AGENDA
HAILEY PLANNING & ZONING COMMISSION
Monday, March 1, 2021
Virtual Meeting
5:30 p.m.

FINDINGS OF FACT, CONCLUSIONS OF LAW AND DECISION

On February 17, 2021, the Hailey Planning and Zoning Commission considered and approved a Design Review Application by Stephen Kearns, represented by Jay Cone Architecture PC, for a new 728 square foot garage with a 678 square foot Accessory Dwelling Unit (ADU) above. This project is located at 12 West Elm Street (Lot 11 and N. 20' of Lot 12, Block 8 and Block 20 x 120 Elm Street) within the General Residential (GR) and Townsite Overlay (TO) Zoning Districts.

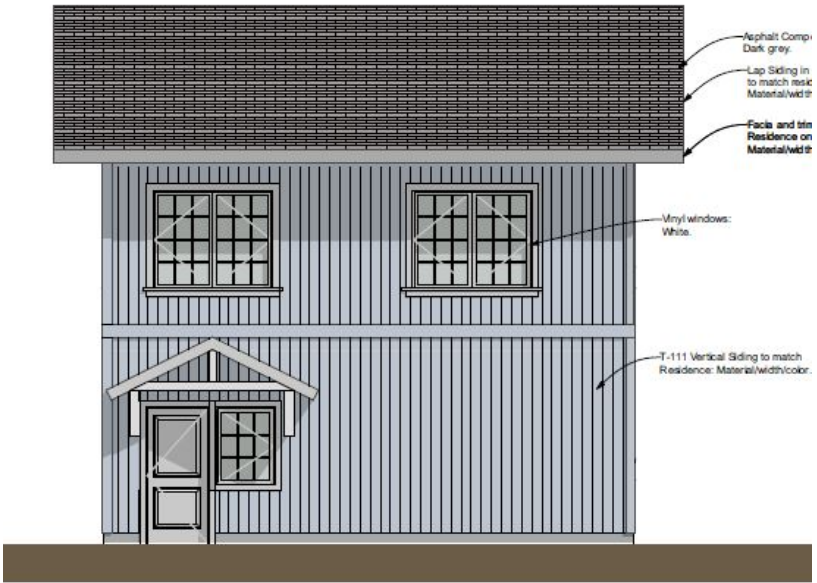
| | | | Staff Comments | <p><i>The Applicant will install Dark Sky compliant fixtures, downcast and low wattage fixtures. Cut sheets are attached.</i></p> |

| | | | |  <p><i>The Commission found that this standard has been met.</i></p> |

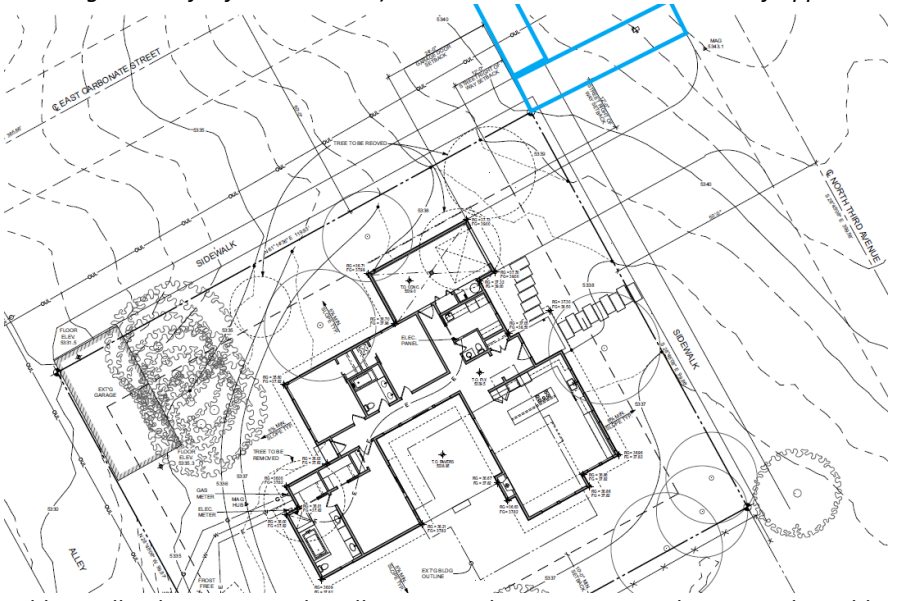
| <input checked="" type="checkbox"/> | <input type="checkbox"/> | <input type="checkbox"/> | 17.06.070(A)1 Street Improvements Required Staff Comments | <p>Sidewalks and drainage improvements are required in all zoning districts, except as otherwise provided herein.</p> <p><i>Sidewalks are existing along the property frontage of Third Avenue and Carbonate Street. That said, neither sidewalk extends to the edge of asphalt on Carbonate Street or Third Avenue. The Public Works Department recommends that the sidewalk along Carbonate Street and Third Avenue be extended to the</i></p> |
| | | | | <p>edge of asphalt on both Carbonate Street and Third Avenue (see the blue lines in the image below for further details). This has been made a Condition of Approval.</p>  <p>Additionally, the existing sidewalks may need some repairing; however, the Public Works Department is unable to provide specific details until the snow melts. The Applicant shall repair the existing sidewalks, as outlined by the Public Works Department. This has been made a Condition of Approval.</p> |

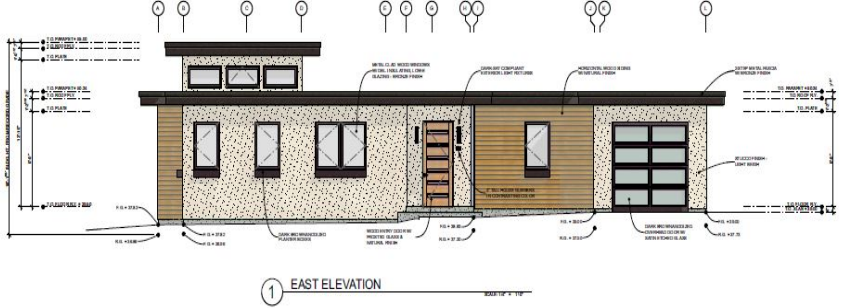
| | | | <i>Staff Comments</i> | <p>The architectural style of the proposed residence is that of a mid-Century Usonian Design. Per the Applicant, Usonian Homes are typically small, single-story dwellings without a garage or much storage. They are often L-shaped to fit around a garden terrace on unusual and inexpensive sites. They are characterized by native materials; flat roofs and large cantilevered overhangs for passive solar heating and natural cooling; natural lighting with clerestory</p> |
| | | | | <p>windows; radiant-floor heating. Another distinctive feature is that they typically have little exposure to the front/public side, while the rear/private sides are completely open to the outside. A strong visual connection between the interior and exterior spaces is an important characteristic of all Usonian Homes.</p>  <p>1 EAST ELEVATION</p> |

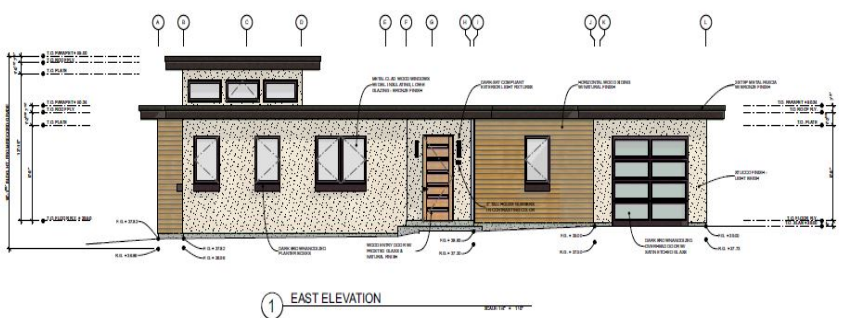
| | | | Staff Comments | <p>The proposed residence will complement that of the surrounding neighborhood. The proposed exterior materials include: horizontal wood siding with a natural finish, stucco finish in light beige, two-step metal fascia with bronze finish, a dark brown anodized overhead door with stain etched glass, and metal clad wood windows with a bronze finish. Dark brown anodized planter boxes will be added under most windows, and a wooden entry door with frosted glass will finish the exterior materials (see image below for further detail).</p>  <p style="text-align: center;">① EAST ELEVATION</p> |
